TRANSMISSION—5R55W—HARSH UPSHIFT AT LIGHT TO MEDIUM THROTTLE—VEHICLES EQUIPPED WITH 4.6L ENGINE—VEHICLES PRODUCED THROUGH 9/21/2001	Article No. 01-20-3

FORD: 2002 EXPLORER

MERCURY: 2002 MOUNTAINEER

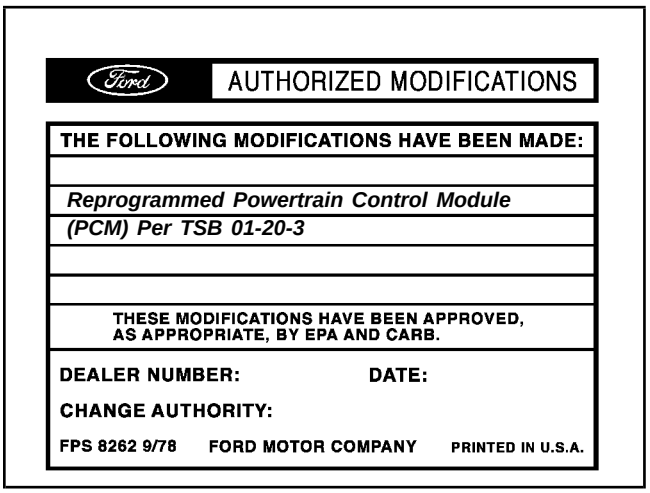
Obtain an Authorized Modifications Decal (STAT 5941-2 - obtainable through the PDC) and list the date, dealer number, and summary of modifications performed. Select a prominent place adjacent to the Vehicle Emission Control Information Decal suitable for installing the Authorized Modifications Decal. Clean the area, install the decal, and cover it with a clear plastic decal shield.
